City of Hutto

Planning and Zoning Commission

Tuesday, June 6, 2023 at 7:00 PM

RE: Lidell Walker Phase 1 Final Plat, Hutto, TX 78634
Final Plat Review – Lidell Walker Phase 1 Final Plat - Comment Report to Update #1 Submittal (received 5-8-23)
Project No.: 2057-PLAT

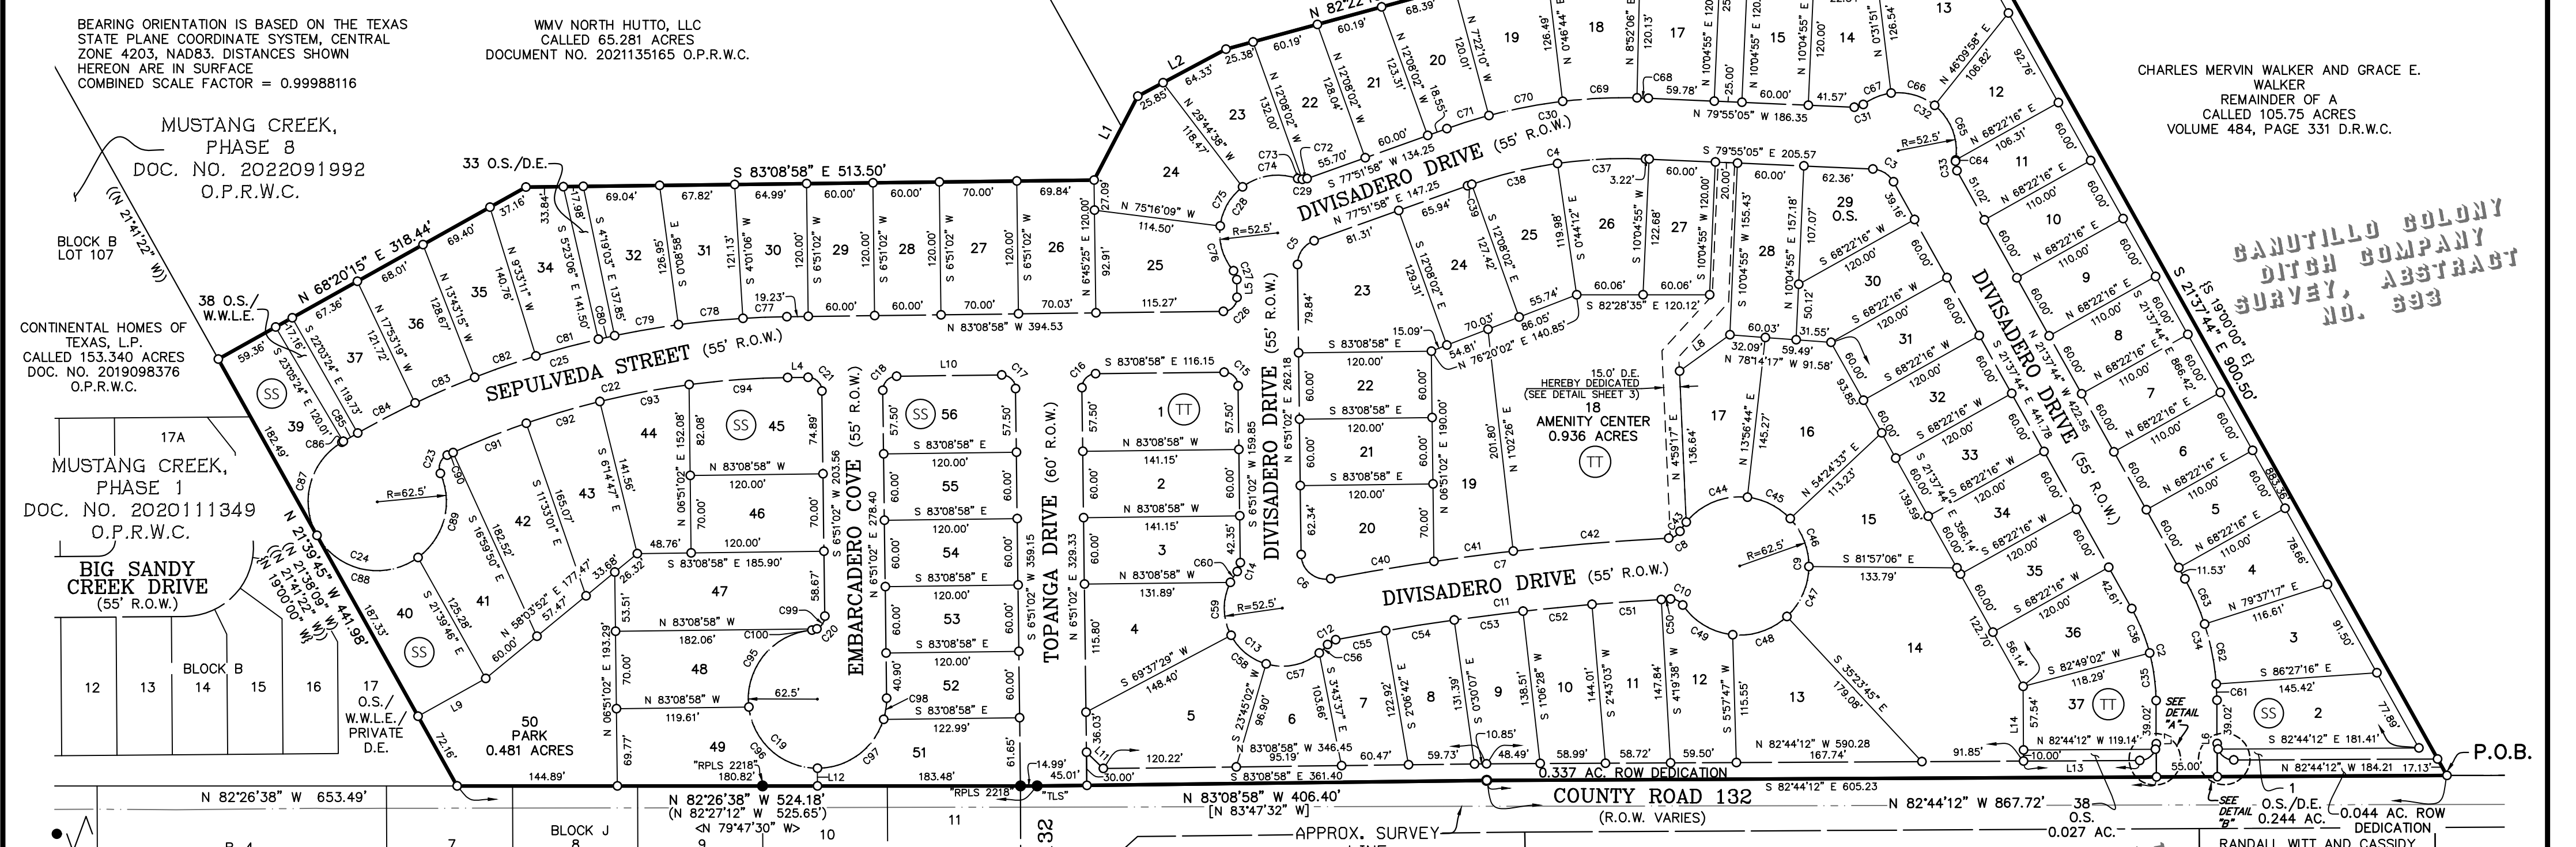
Please add a note stating TIF will be due based on Ordinance 2021-014

Soil Map

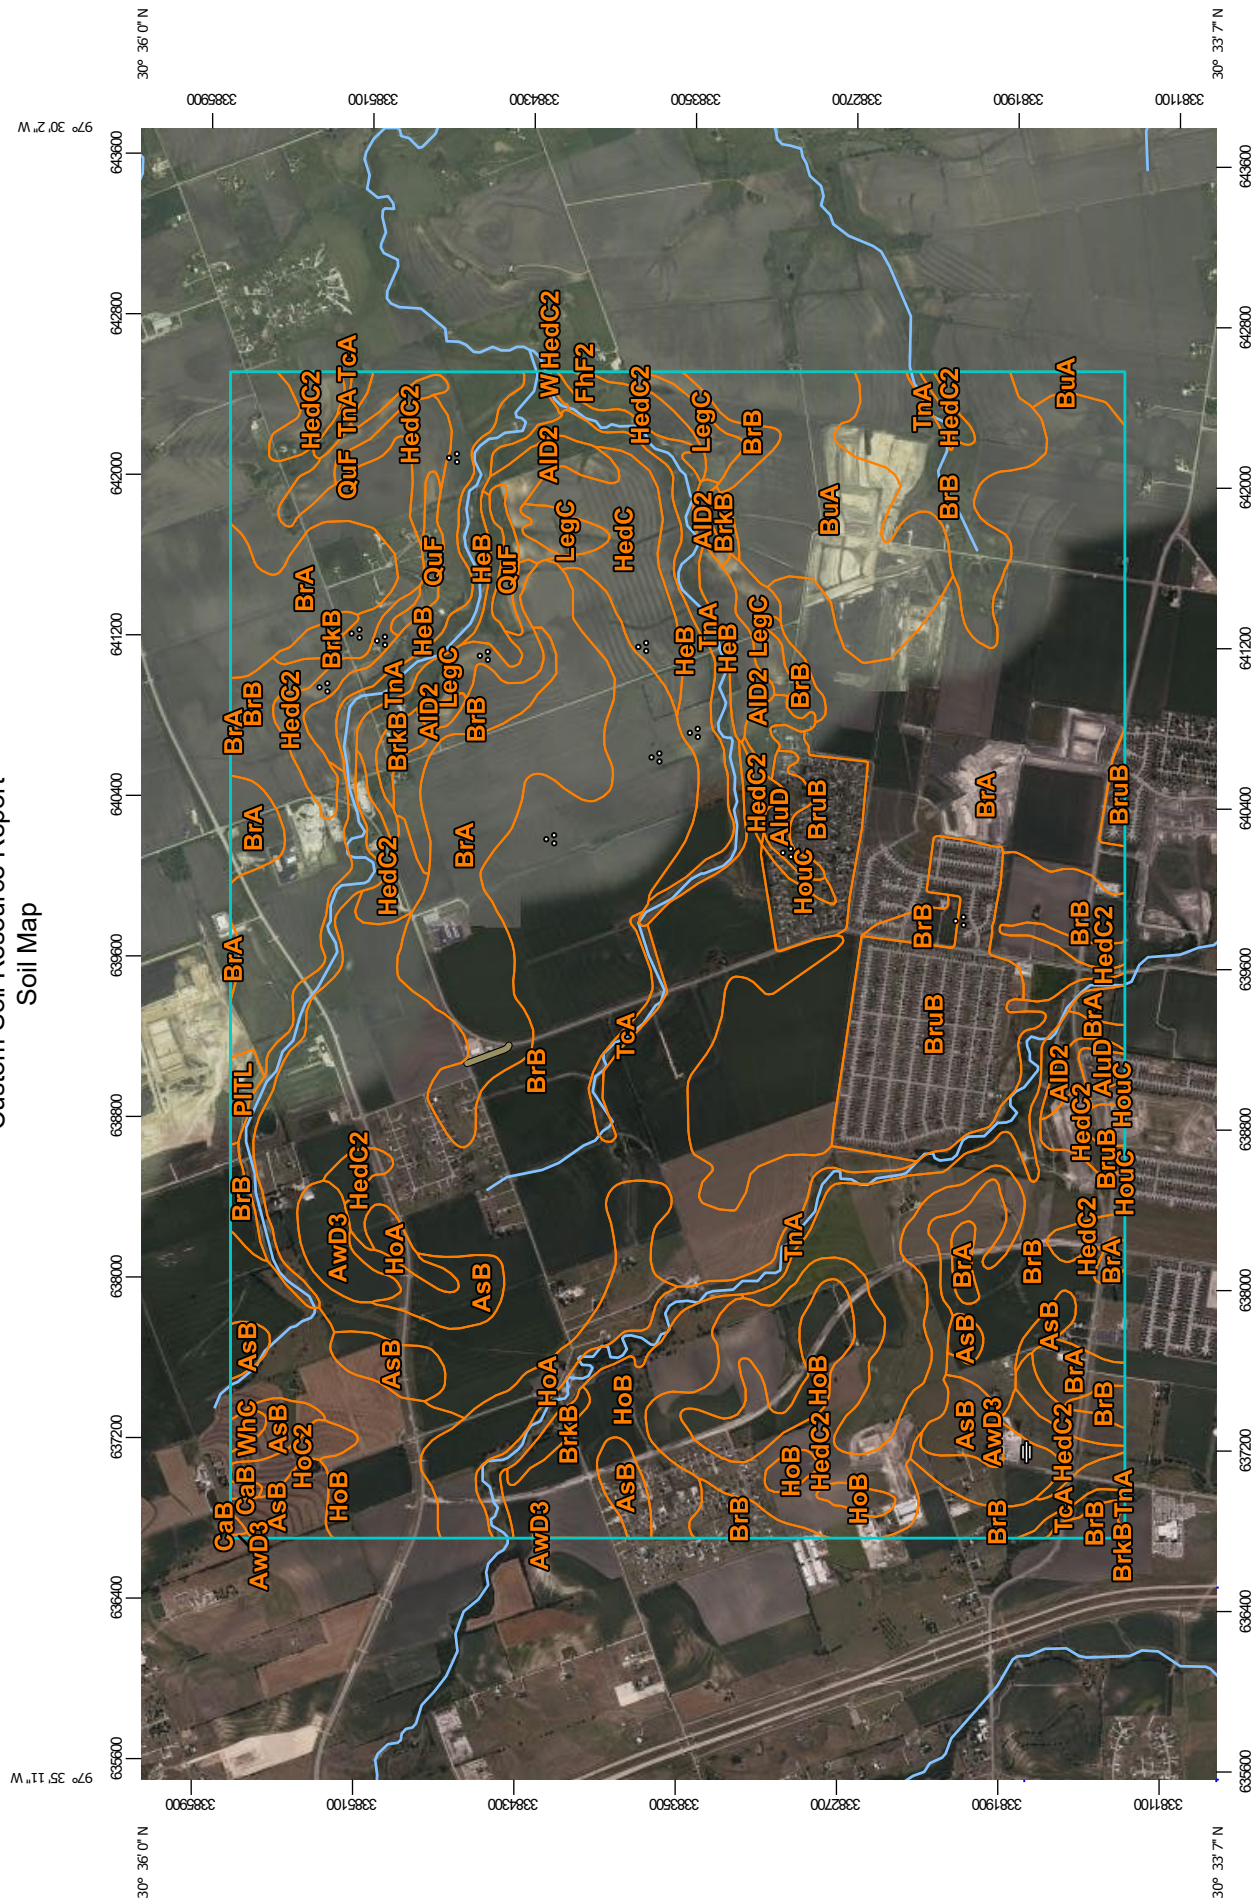
There are no "Row Crops" listed in the DACS. Please clarify and ensure that all classifications and CN values comply with the DACS.

BGE-CALCULATED 100-YR FULLY DEVELOPED FLOODPLAIN

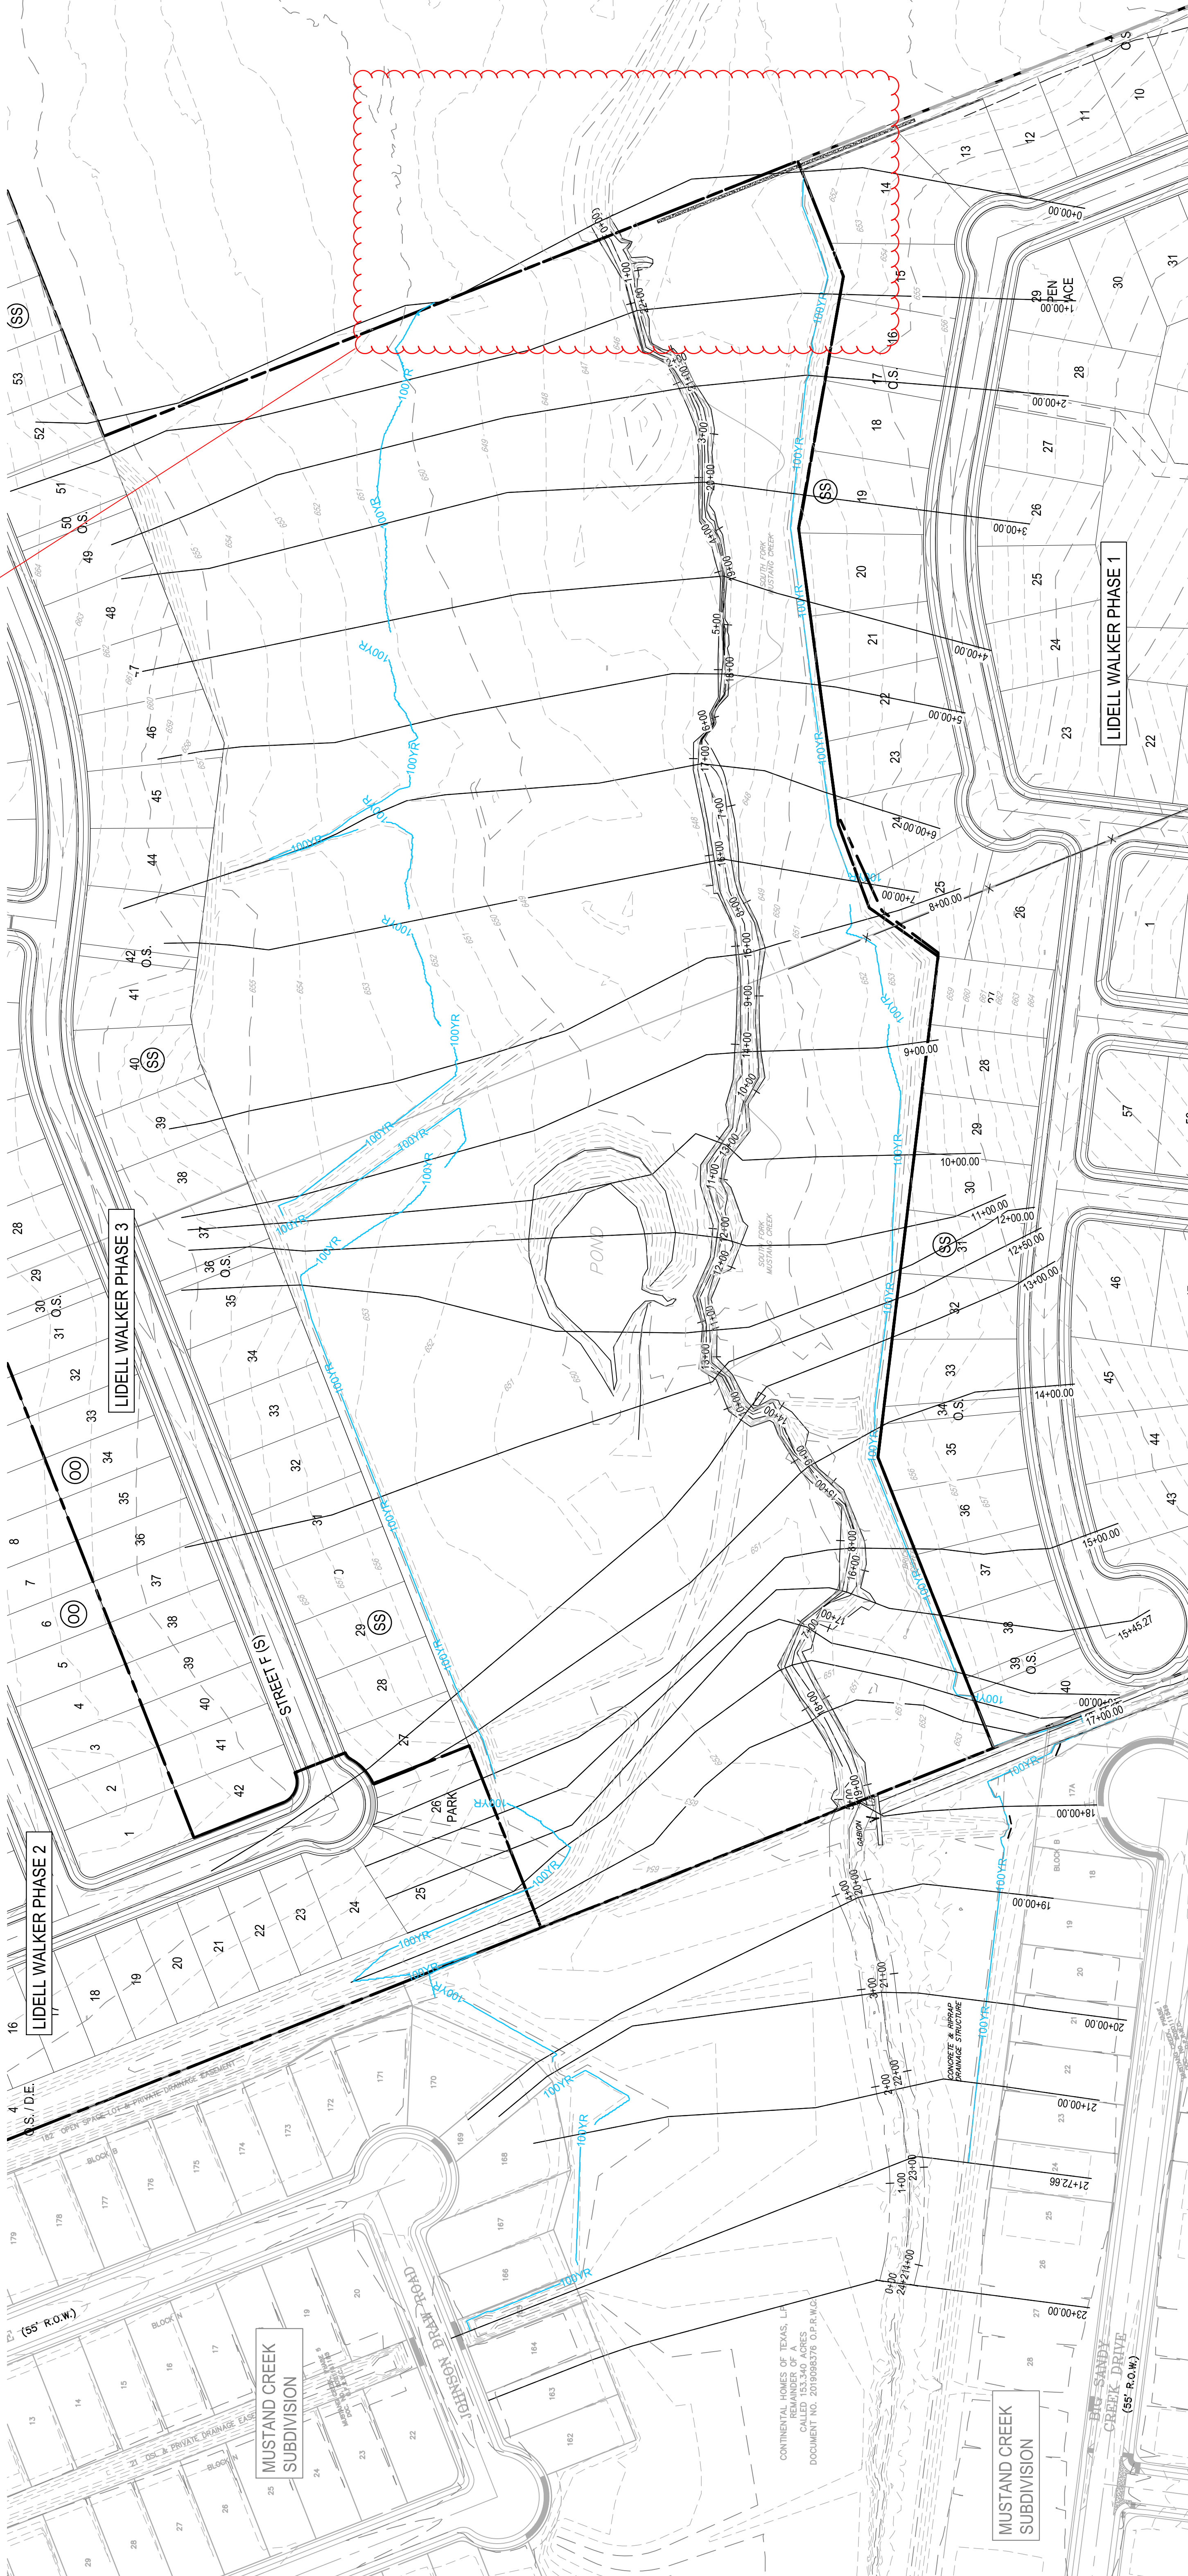
since this model ends at the road and not at the end of the existing model further down stream please clarify what the floodplain information is based on.
